LETTER OF SUBMITTAL
KFM Skyway Project # 04-012024

Subject: Kie-Con NCR for fender module FP-1-30

Subject: KFM SUB# 6036 Kie-Con NCR-302-001 for Fender Module FP-1-30

KFM-SUB#6036 Kie-Con NCR-302-001 for Fender Module FP-1-30

OPTION 1

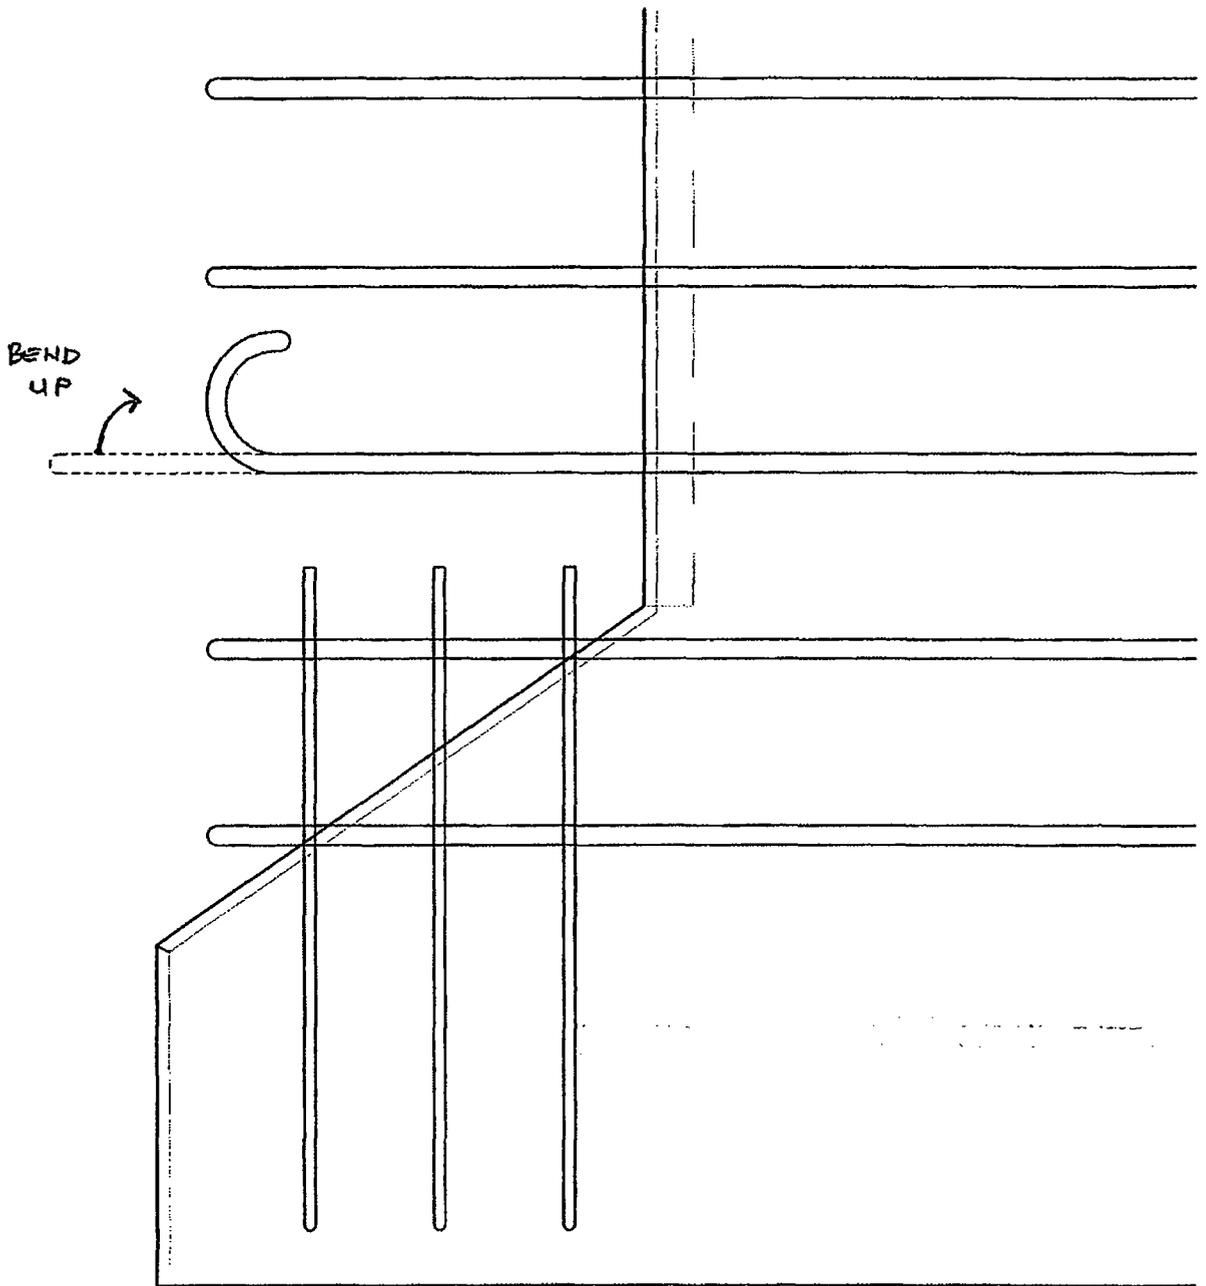
Option 1: The U-Bar will be bent (upward or downward and back) 180 degrees without cutting the rebar. This way the bar is still developed per plans and specification. Any damaged epoxy shall be patched.

Based on potential constructability issues at the job site, either option 3 or 4 seems the best suited option for the rebar shortening. However, in regard to loss of reinforcement, associated with this rebar movement within the Fender and its consequences relating to the capacity of the fender, OSM defers to the Design.

OPTION 2

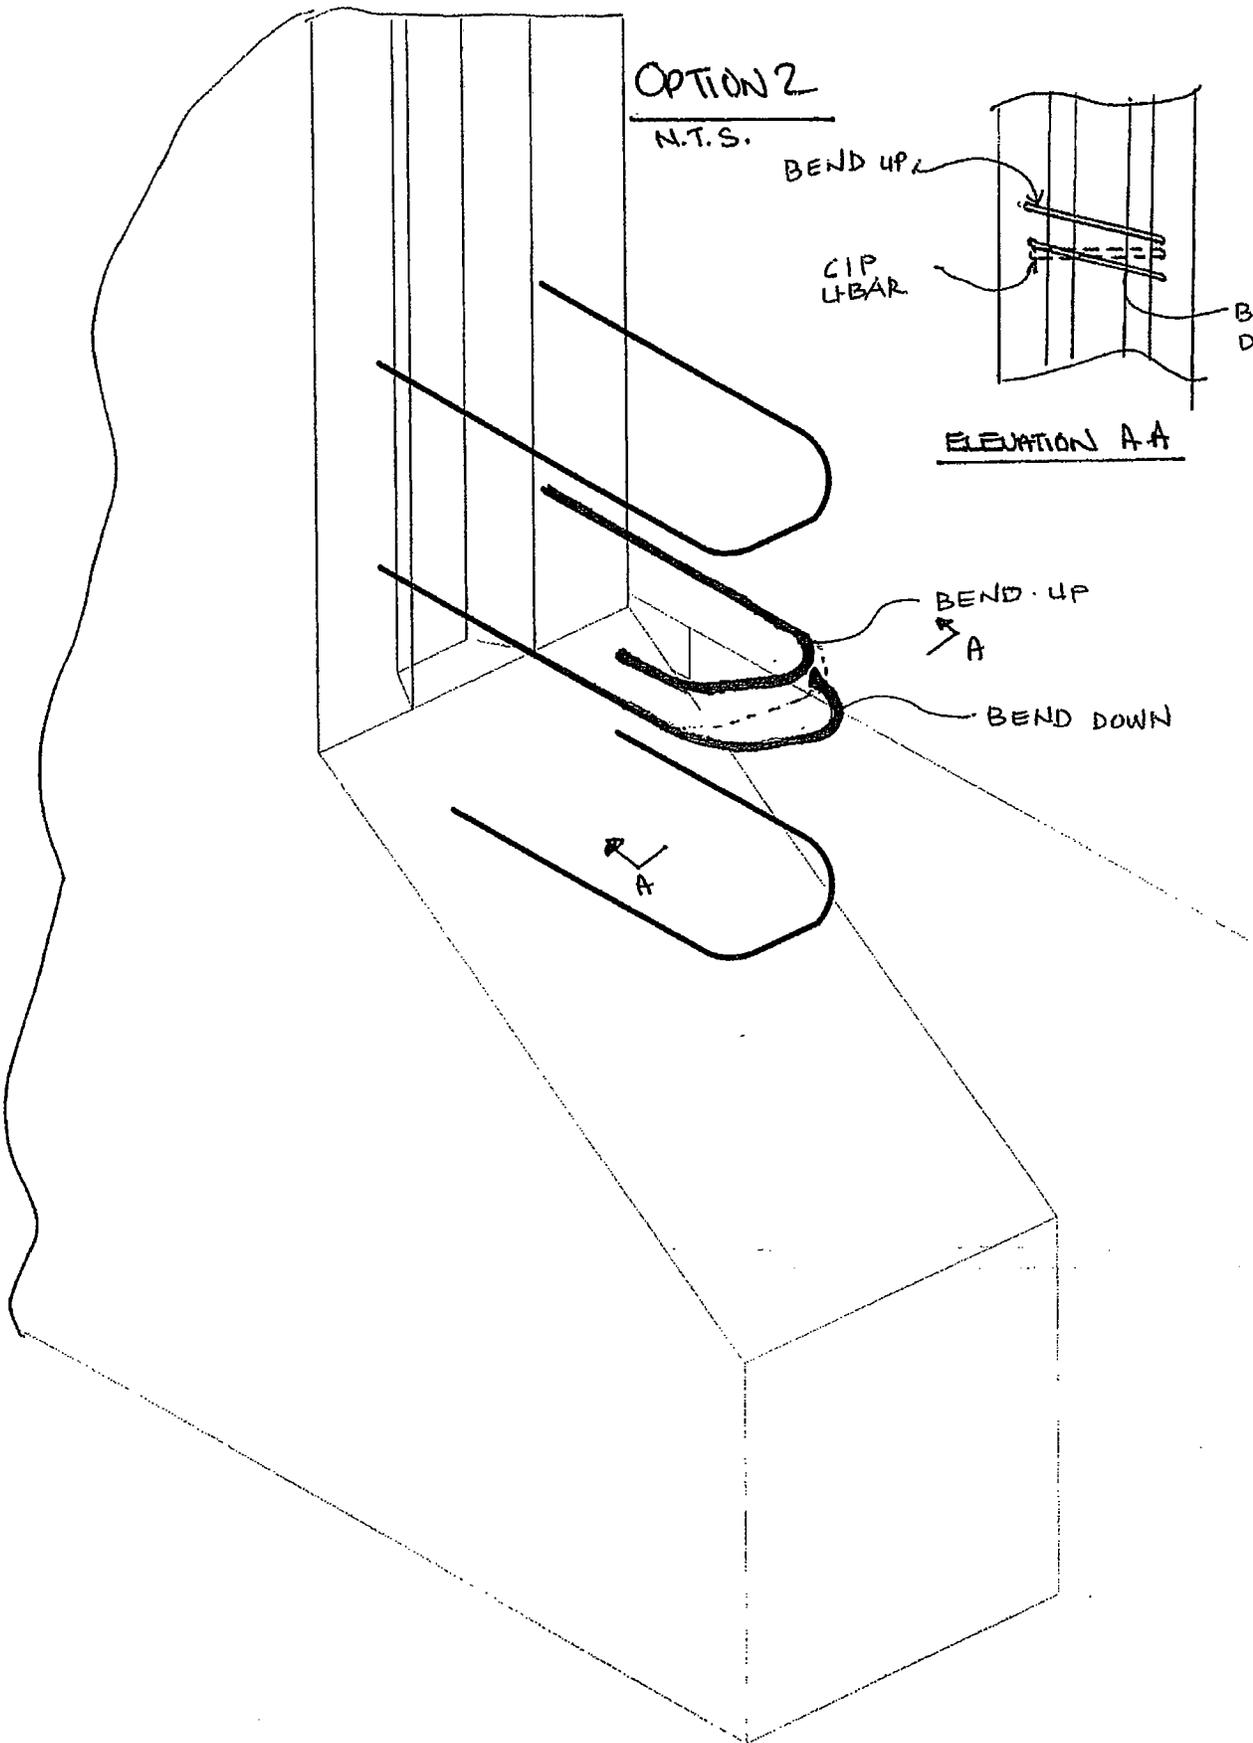
Option 2: The U-Bar will be cut in the middle of existing radius. Each Individual bar will be bent 90 degrees to create a hook at the end of them. Any damaged epoxy shall be patched.

OPTION 3

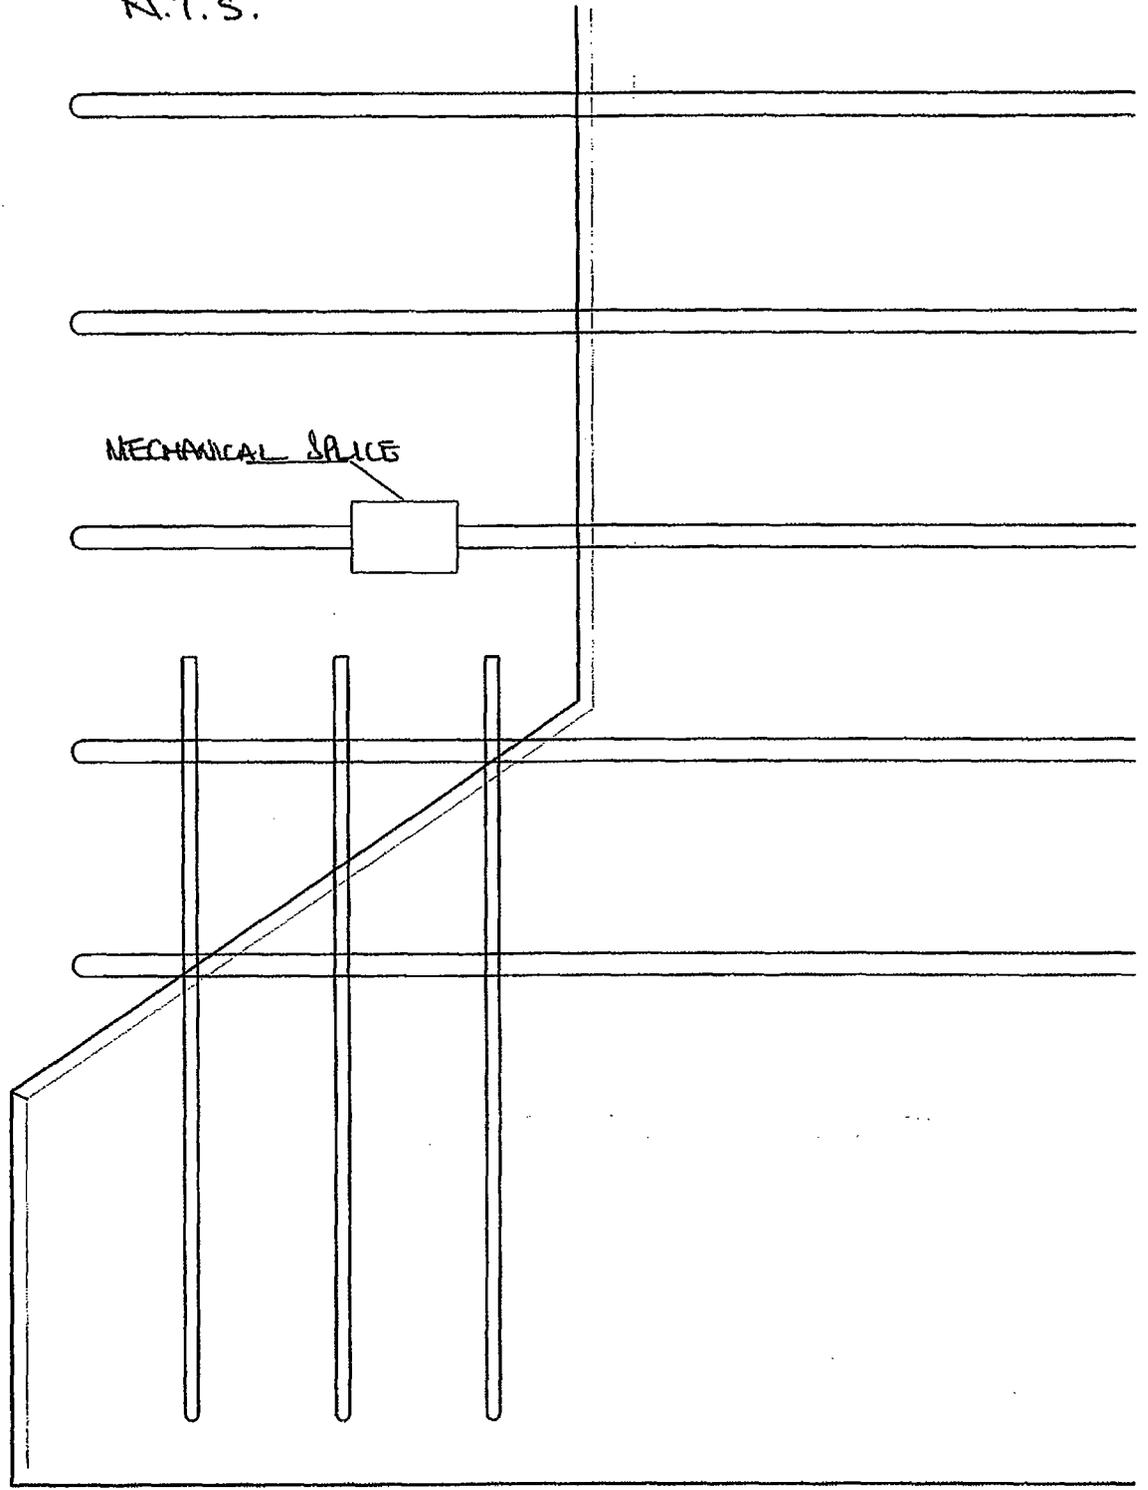
Option 3: The U-Bar will be cut in a specified location provided by KFM due to the job site conditions. It will be then spliced with a new fabricated U-Bar using a mechanical splice. The mechanical splice shall be epoxy coated or it shall be shrink wrapped per project specifications.

OPTION 4
N.T.S.

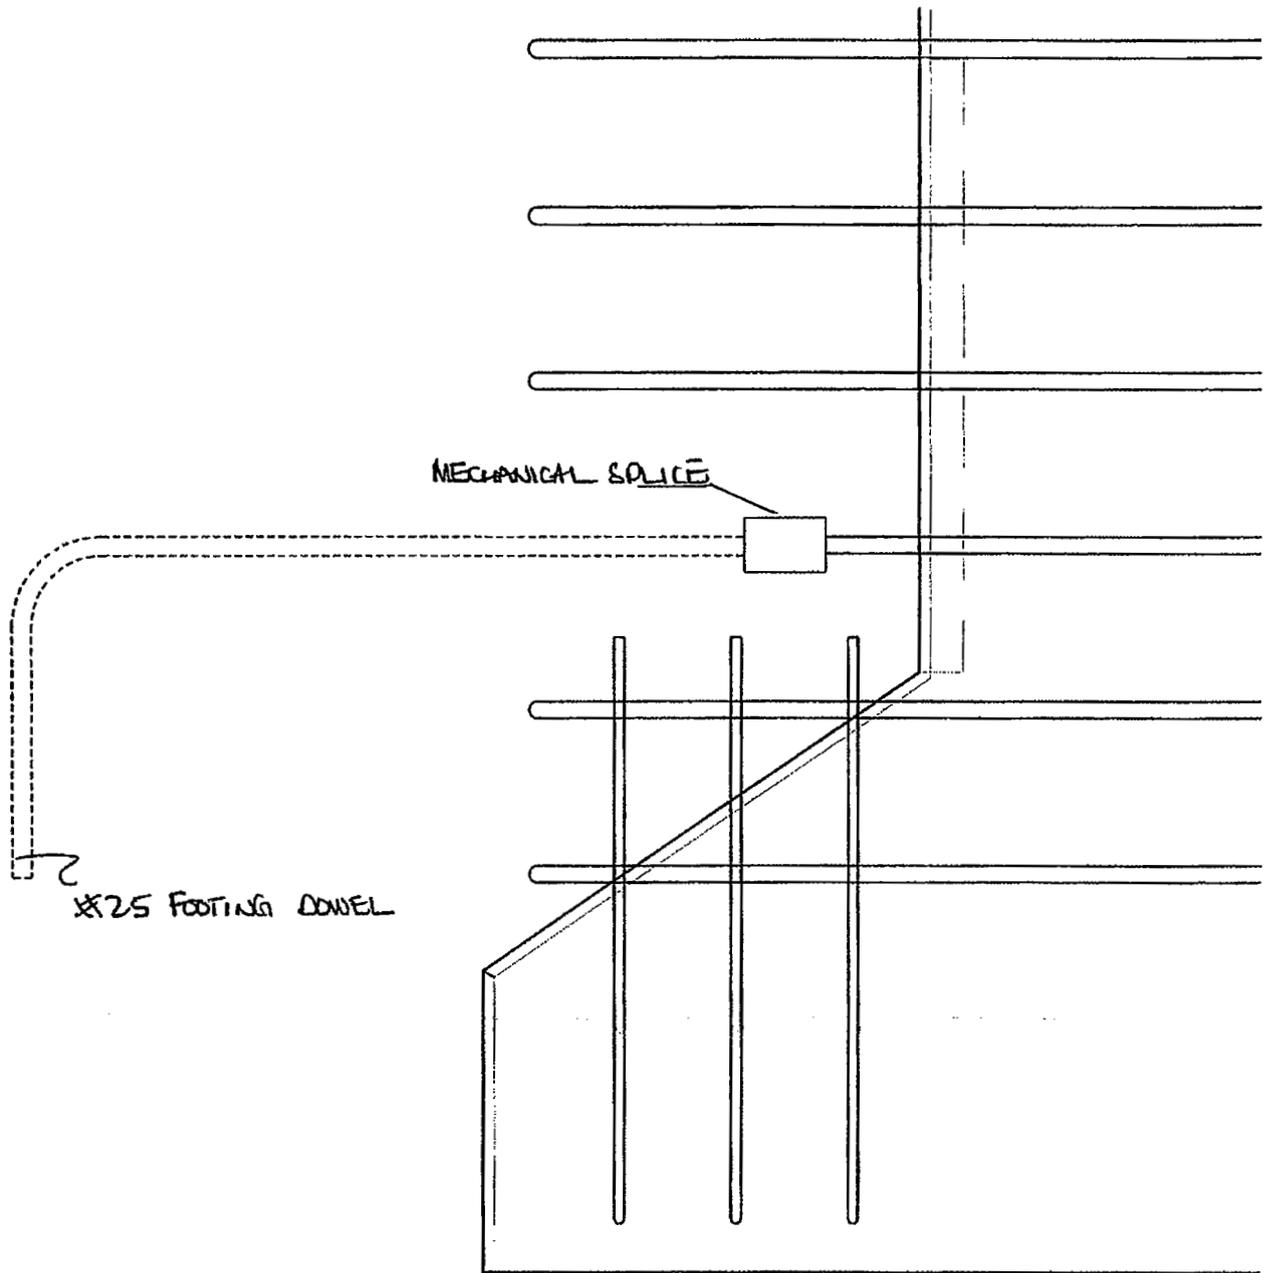
Option 4: The U-Bar will be cut in a specified location by KFM due to the job site conditions. It will be then spliced with the matching #25 dowel coming out of the pier using a mechanical splice. The mechanical splice shall be epoxy coated or it shall be shrink wrapped per project specifications.
